PURCHASING

MEMO TO: Prospective Bidders

SUBJECT: **Addendum #4:** Locks Creek Drainage Improvements

CITY OF FAYETTEVILLE -
LOCKS CREEK DRAINAGE IMPROVEMENTS

1

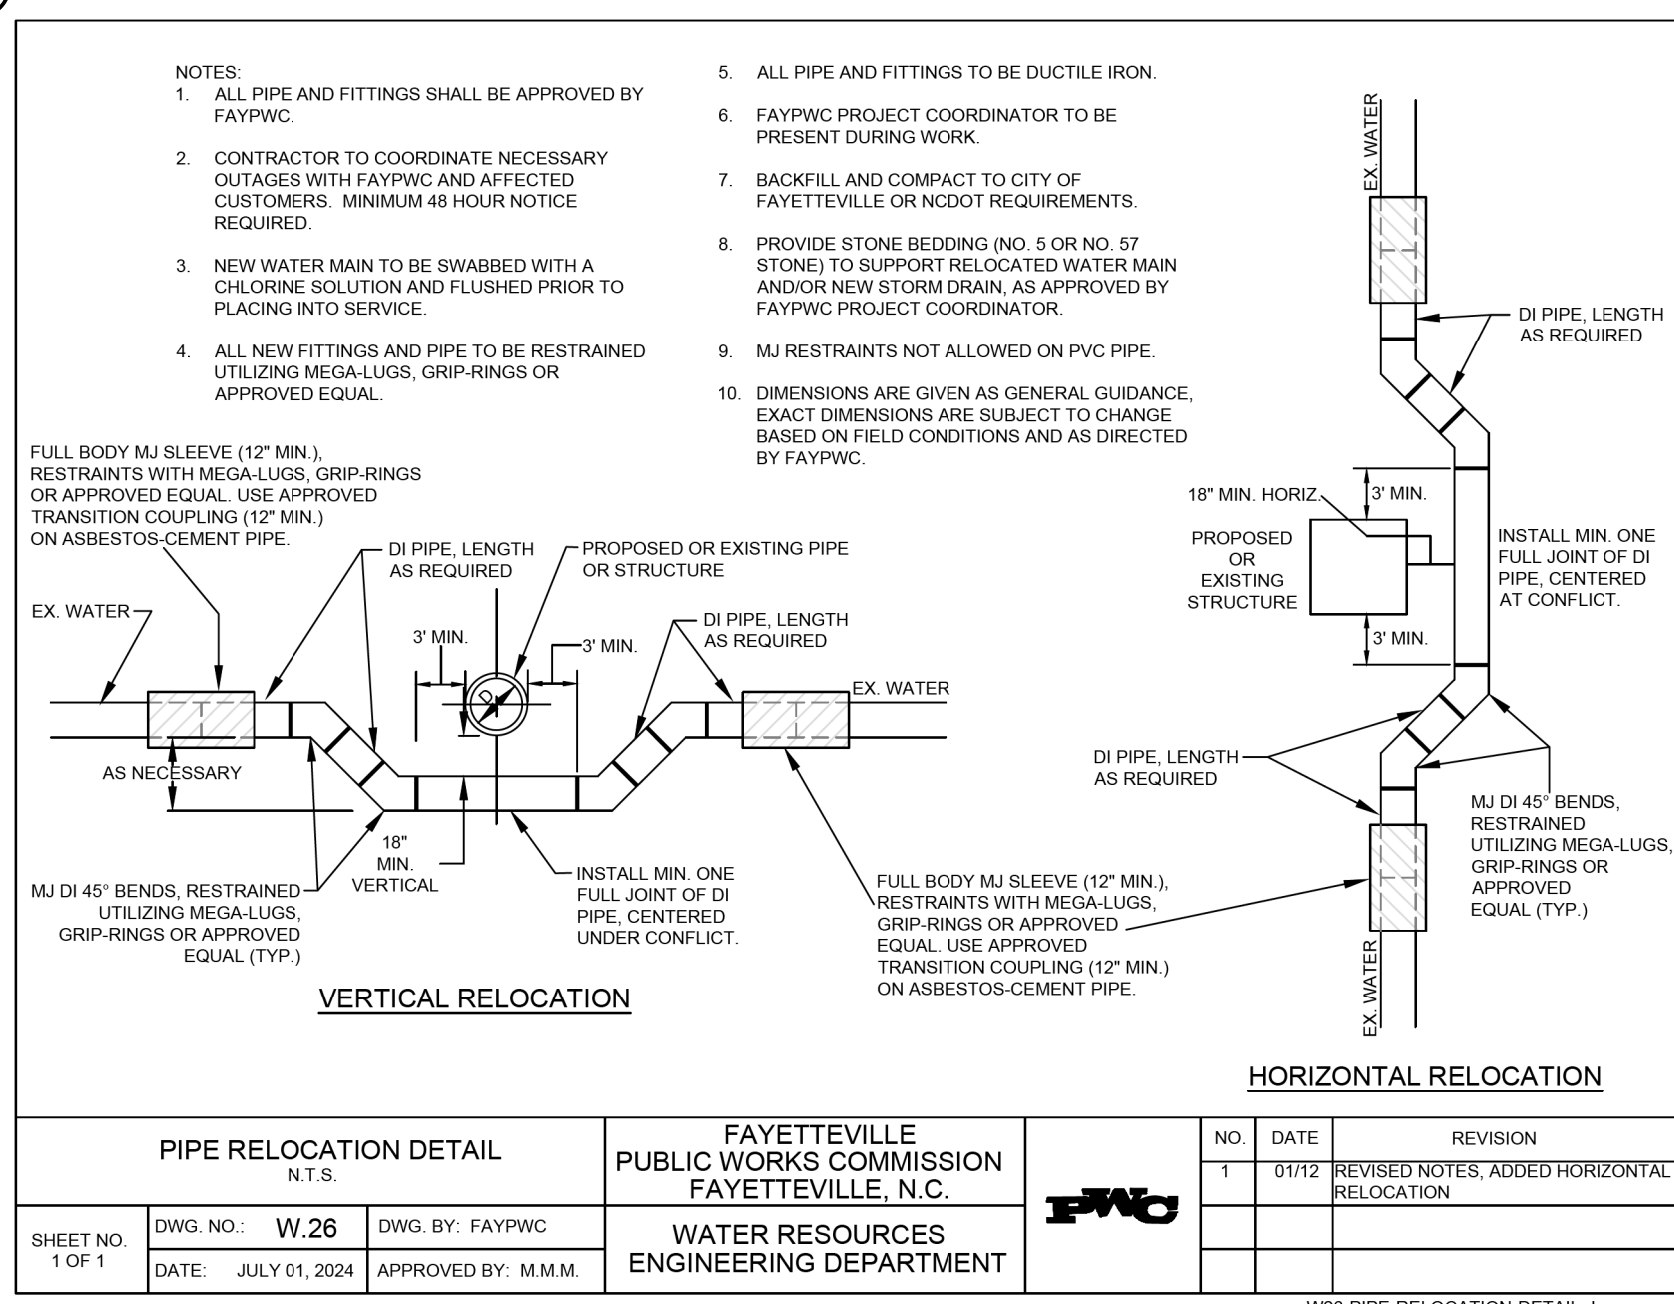
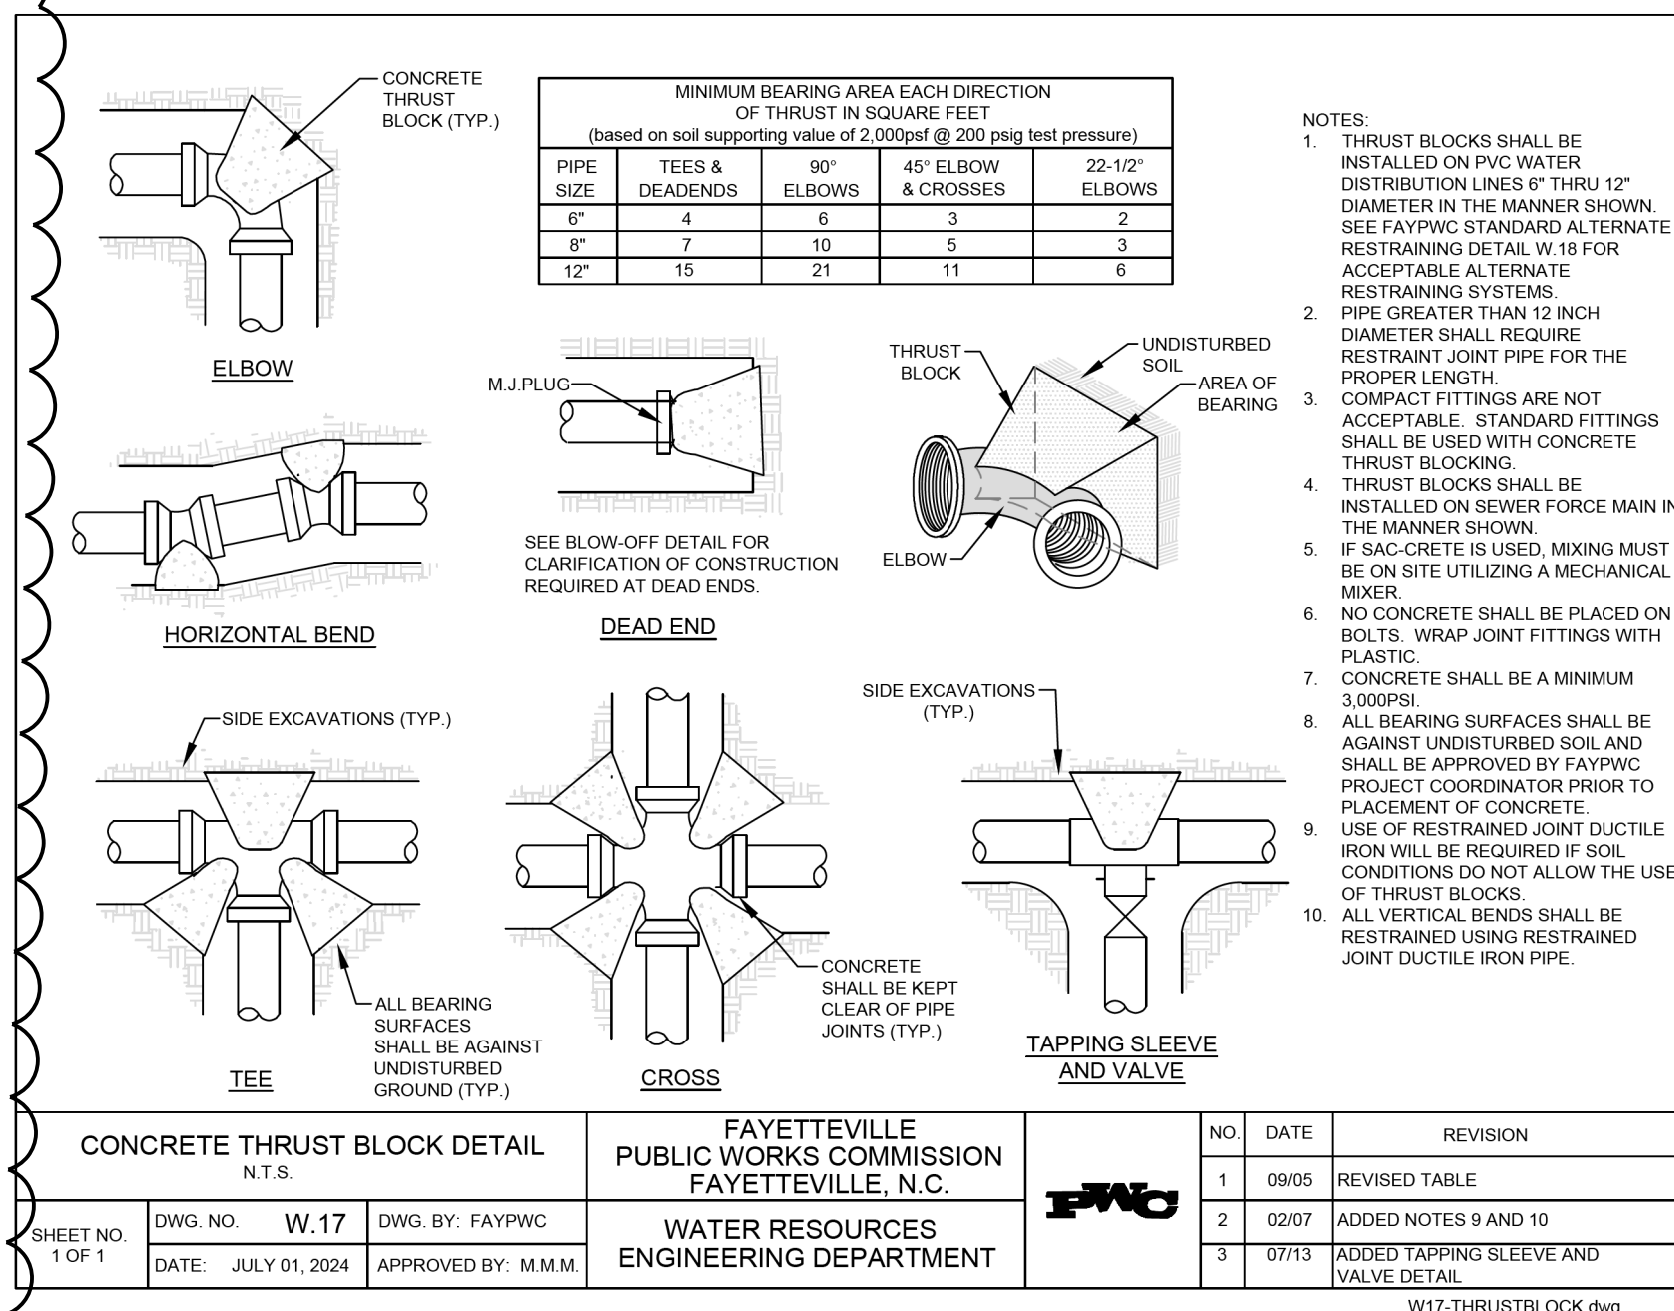
- i. CU-01 with revised water main design
- ii. CU-02 with revised water main design
- iii. CU-02A showing temporary water main bypass
- iv. CU-03 referencing updated construction sequencing on other sheets
- v. DT-04 – construction detail sheet with addition of fire hydrant assembly

- PROVISION OF TEMPORARY WATER MAIN TO ACCOMMODATE BOX CULVERT CONSTRUCTION AND UTILITY WORK RELATED TO REMOVAL AND REPLACEMENT OF FAYETTEVILLE PVC - 8" WATER MAIN:

- TEMPORARY WATER MAIN PLAN LAYOUT:
- TEMPORARY 6" WATER MAIN BYPASS SCHEMATIC LAYOUT ROUTE SHOWN ON THIS PLAN. THE BYPASS SHALL BE INSTALLED TO ACCOMMODATE FAYETTEVILLE PWC REQUIREMENTS TO MINIMIZE SERVICE DISRUPTION FOR THE REMOVAL AND RELOCATION OF THE EXISTING 8" WATER MAIN. THE CONTRACTOR SHALL PROVIDE A DETAILED PLAN, SHOP DRAWINGS AND SUBMITTALS TO THE ENGINEER AND FAYETTEVILLE PWC FOR REVIEW AND APPROVAL PRIOR TO IMPLEMENTATION AND COMMENCEMENT OF THE WORK AND IN ACCORDANCE WITH THE STANDARDS AND REQUIREMENTS NOTED ABOVE.
